ULNRC-04928

**DOCKET NUMBER 50-483  
CALLAWAY PLANT  
UNION ELECTRIC COMPANY  
RESPONSES TO REQUESTS FOR ADDITIONAL INFORMATION  
PROPOSED REVISION TO TECHNICAL SPECIFICATION 1.1,  
"DEFINITIONS"; TECHNICAL SPECIFICATION 3.7.3  
"MAIN FEEDWATER ISOLATION VALVES (MFIVs)"; AND  
STEAM GENERATOR TUBE RUPTURE WITH OVERFILL RE-ANALYSIS**

Reference: ULNRC-04592, dated June 27, 2003

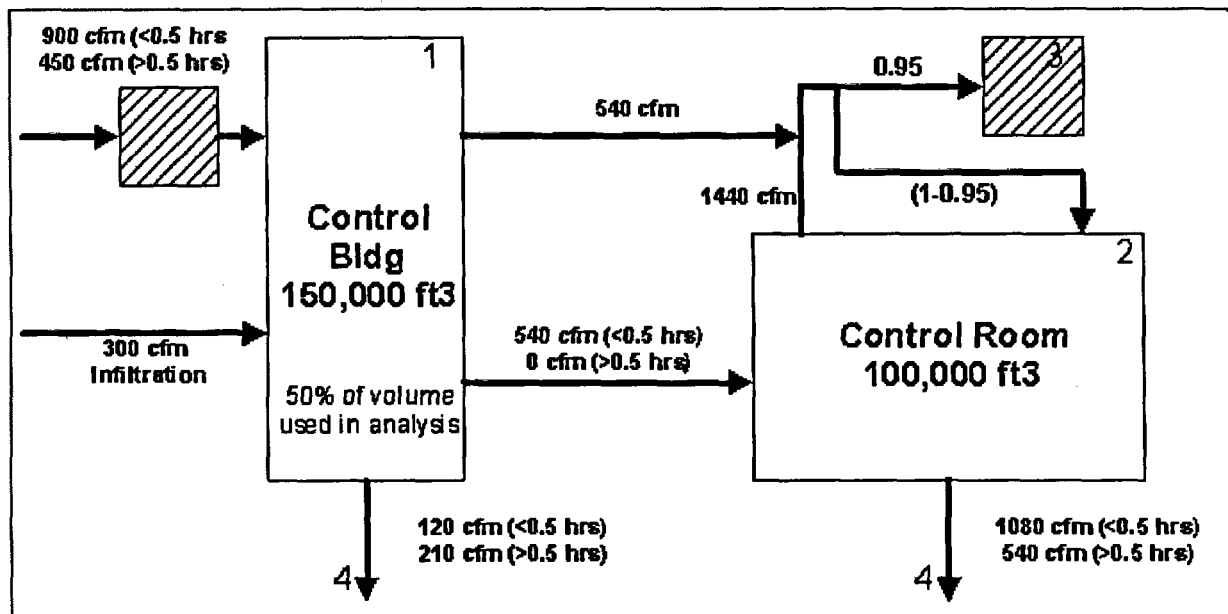
Figures 15.6-3P, 15.6-3.2d, and 15.6-3.2h of the submittal provide data for the intact steam generators (SGs). Discuss if the data represents each intact SG or the total for all intact SGs.

The intact SG figures represent a lumped SG that is representative of the 3 intact SGs.

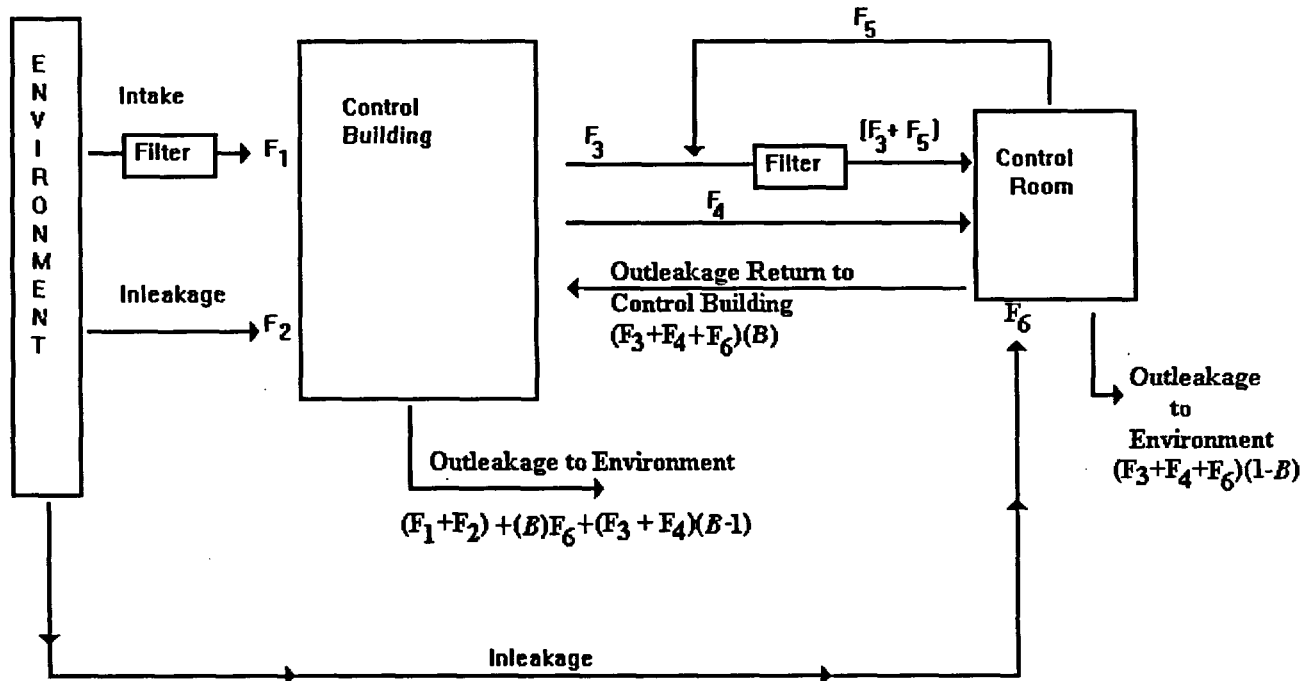
The figure below represents the staff's interpretation of appropriate modeling of your control building and control room. Node 3 is the recirculation filter; node 4 is a "sink." Discuss the staff's interpretation and confirm if the staff's understanding is correct. In particular, discuss if the expected re-alignment will occur at 30 minutes for this event and provide the basis for this conclusion.

In addition, respond to the following questions transmitted to AmerenUE on November 18, 2003. AmerenUE provided an alternative figure from the FSAR for the control room/control building/environment flow interactions. Although the response identifies two flow paths not shown on the staff's figure, insufficient data is provided for the staff to determine the flow rate in these two paths.

- (1) What is the value of the direct inleakage to the control room (F6)? Is this equal to F2?
- (2) What is the value of the constant "B" shown in the figure for determining outleakage from the control room returning to the control building? This constant is identified as the fraction of outleakage that returns to the control building. What is the constant based upon? Does the same value apply to the other two outleakage expressions as well?

The staff's flow diagram does not match the one used by AmerenUE. The following diagram is taken from Section 15A of the Callaway FSAR:

The diagram has two flow paths not shown on the staff's diagram. The first is direct inleakage from the environment to the Control Room. The second represents Control Room outleakage returning to the Control Building.
